# Access Compliance Report

## Public Rights-of-Way

### (Curb Ramps)

Intersection ID: 44823	Main Street: SPRING_OAK_DR	Cross Street: GOLDEN_RIDGE_LN	Location: SW
ADA ID: 1084A412CE73	Ramp Type: PerpDiag	Initial Pass/Fail: Fail	Overall Compliance: No
Severity Score: 42.5			
Codes/Mitigation Info/Possible Solution		Field Measurements/Component Compliance

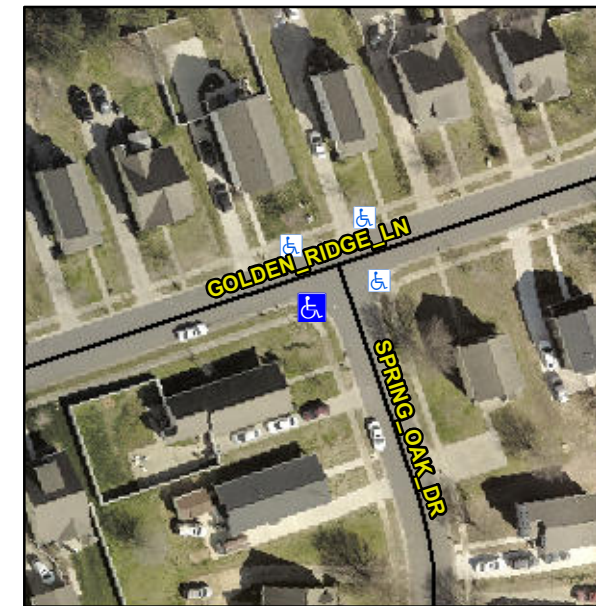
Compliance	Description	Data	Compliance	Description	Data
N/A	Ramp Length (in)	96.0	Yes	Ramp Slope (%)	7.2
No	Ramp Width (in)	35.0	No	Ramp XSlope (%)	13.1
N/A	Flare Type LT	N/A	N/A	Flare Type RT	N/A
N/A	Flare Slope LT (%)	N/A	N/A	Flare Slope RT (%)	N/A
N/A	Flare Traversable LT?	N/A	N/A	Flare Traversable RT?	N/A
N/A	Landing Length (in)	N/A	N/A	DWS Provided?	N/A
N/A	Landing Width (in)	N/A	N/A	DWS Contrast?	N/A
N/A	Landing Slope (%)	N/A	N/A	DWS Length (in)	N/A
N/A	Landing X Slope (%)	N/A	N/A	DWS Full Width?	N/A
N/A	Landing Curb? (Y/N)	N/A	N/A	DWS Offset (in)	N/A
N/A	Shared Landing?	N/A			
N/A	Gutter Ponding?	N/A	N/A	Gutter Slope (%)	N/A
N/A	Gutter Lip Ht (in)	N/A	N/A	Gutter X Slope (%)	N/A
N/A	Painted X Walk1?	No	N/A	Painted X Walk2?	No
	X Walk 1 Direction	To E		X Walk 2 Direction	To N
N/A	X Walk 1 Width (in)	N/A	N/A	X Walk 2 Width (in)	N/A
	X Walk 1 Slope (%)	3.3		X Walk 2 Slope (%)	4.5
	X Walk 1 X Slope (%)	4.7		X Walk 2 X Slope (%)	5.7

**Remove & Replace Curb Ramp With Two New Directional Ramps or Equivalent.**

**R304.5.1, R304.5.3**
